**Report: Deficiency Report**

**Function: Test, Adjust, & Balance**

**08-18-25 WAWA #6620 ELKTON, VA**

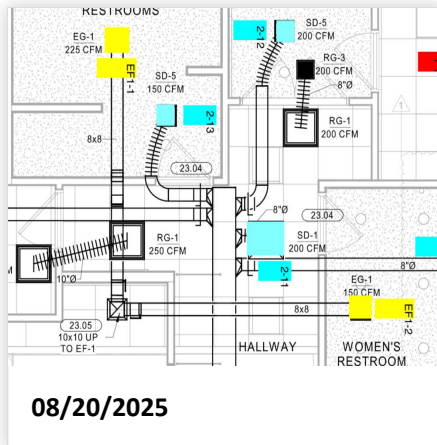
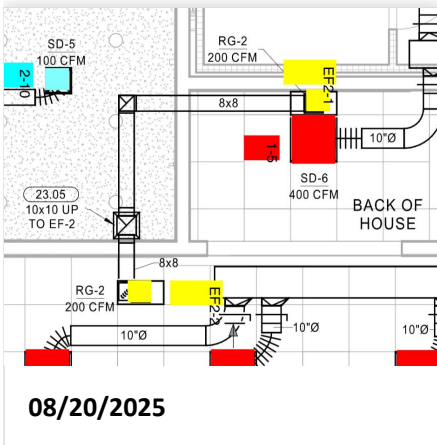
**Issue Name :** Diffuser EF1-2 - Wrong Grille Type  
**Description :** Exhaust diffuser EF1-2 (women's restroom) is using a SD-5 supply grille instead of the required EG-1 exhaust grille. The supply and exhaust grilles in the restroom appear to be swapped. Recommend installing correct grille.  
**Created By :** National TAB                      **Assigned To :** National TAB - Dan Hertenstein  
**Status :** Open  
**Priority :** Low                                      **Asset Tag :**  
**Originated Date :** 08/20/2025 - Mark Johnson - National TAB

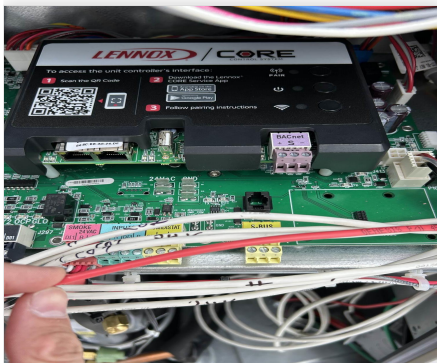
**Issue Name :** Exhaust Ductwork  
**Description :** Exhaust fan ductwork is constructed differently from plans. Mechanical plans specify 8X8 square duct with turning vanes for both rooftop exhaust fans. Installed is 8" round duct with flex at the diffuser connections. This is a 21% reduction of free area and is restricting flow in both exhaust fans. Recommend mechanical inspection.  
**Created By :** National TAB      **Assigned To :** National TAB - Dan Hertenstein  
**Status :** Open  
**Priority :** High      **Asset Tag :**  
**Originated Date :** 08/20/2025 - Mark Johnson - National TAB

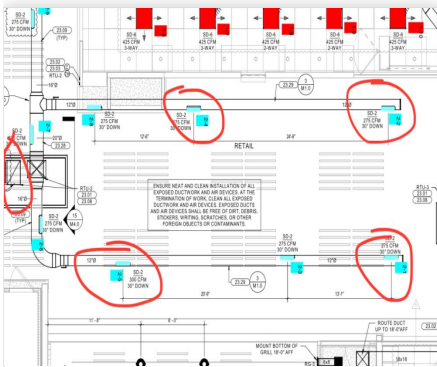
**Issue Name :** RTU 2 - Core Controls  
**Description :** RTU 2's Core control board is not functional. The unit will power on, but the fan remains idle, and parameters cannot be adjusted. Unit cannot be balanced until resolved.  
**Created By :** National TAB                      **Assigned To :** National TAB - Dan Hertenstein  
**Status :** Open  
**Priority :** Urgent                                      **Asset Tag :**  
**Originated Date :** 08/20/2025 - Mark Johnson - National TAB

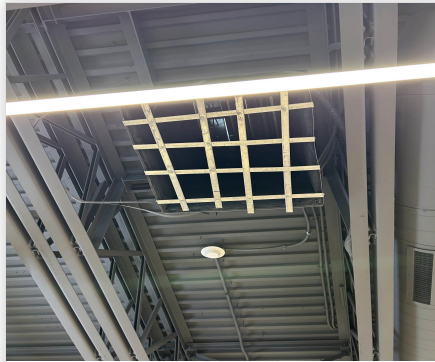
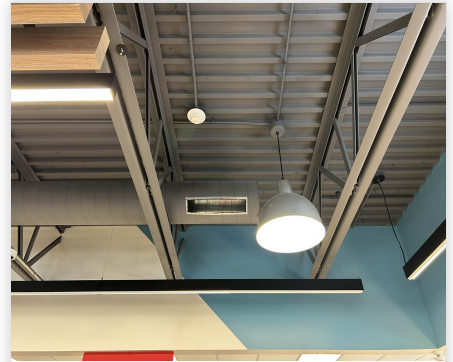
**Issue Name :** RTU 2 - Missing Supply/Return Grilles  
**Description :** RTU 2 is missing several sidewall grilles along the supply duct, and the return grille. Must be installed to balance the individual diffusers.  
**Created By :** National TAB                      **Assigned To :** National TAB - Dan Hertenstein  
**Status :** Open  
**Priority :** High                                      **Asset Tag :**  
**Originated Date :** 08/20/2025 - Mark Johnson - National TAB

- **08/20/2025 National TAB - Mark Johnson**
  - Per GC, missing grilles are on order.
